**PRODUCT MIGRATION**  
**Next Gen**  
**RZ7-FS and RZ7-FE**  
**Timing Relays**

## RZ7-FS and RZ7-FE Timing Relays *Migration*

PUB ID: MIGRATION-RZ7 r3 09/2022

Dimension comparison

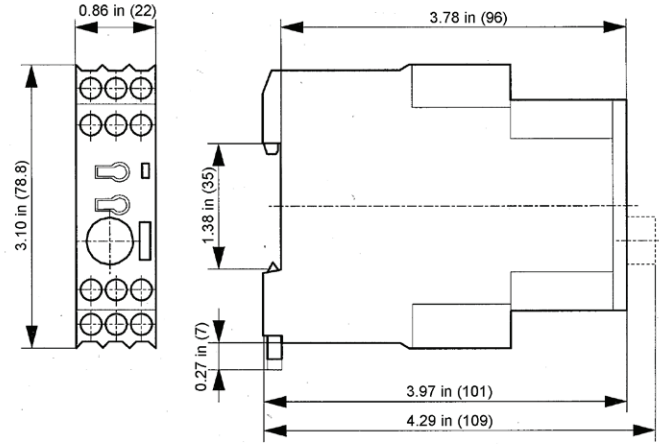
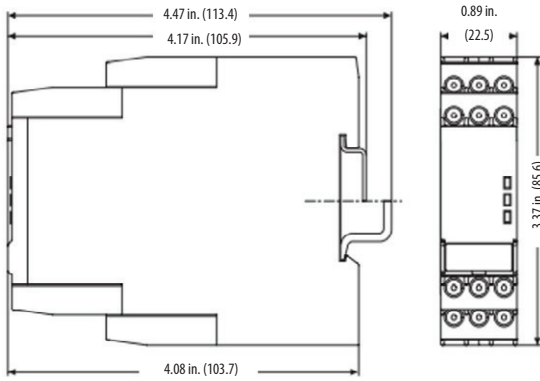
- ❶ Timer has multiple time ranges. Time range dial must be set to your timing range preference.
- ❷ Timer has multiple functions. Function dial must be set to your desired function code.
- ❸ Timer RZ7-FE dimensions are considerably smaller than the RZ7-FS style timer.
- ❹ Timer Voltage range is 12-240V AC or DC.
- ❺ Timer is two-pole (2 C/O) rather than one-pole (1 C/O).

**Next Gen Series RZ7-FS Timing Relays**

**Series RZ7-FS Timing Relays**

**Next Gen Series RZ7-FE Timing Relays**

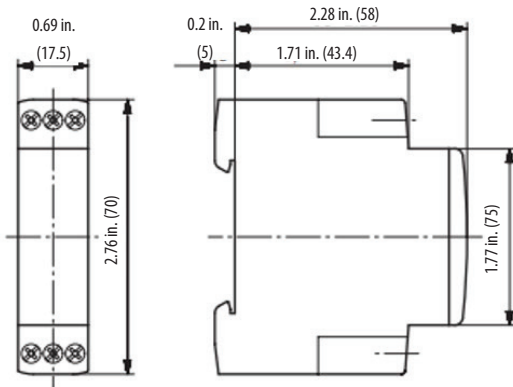
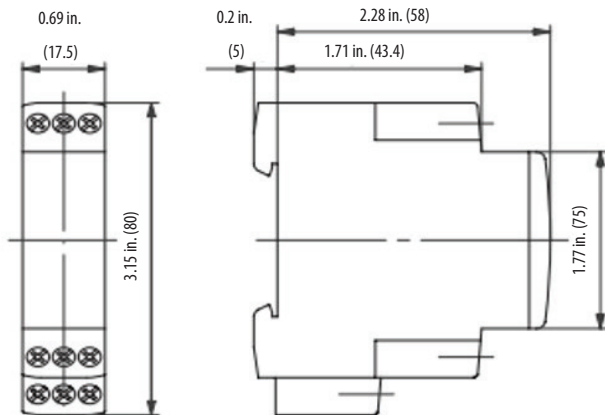
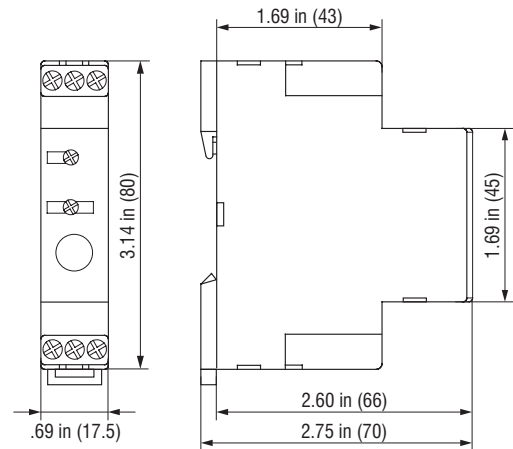
**RZ7-FE with 1 c/o Contact or 2 n/o Contacts**

**RZ7-FE with 2 c/o Contacts**

**Series RZ7-FE Timing Relays**
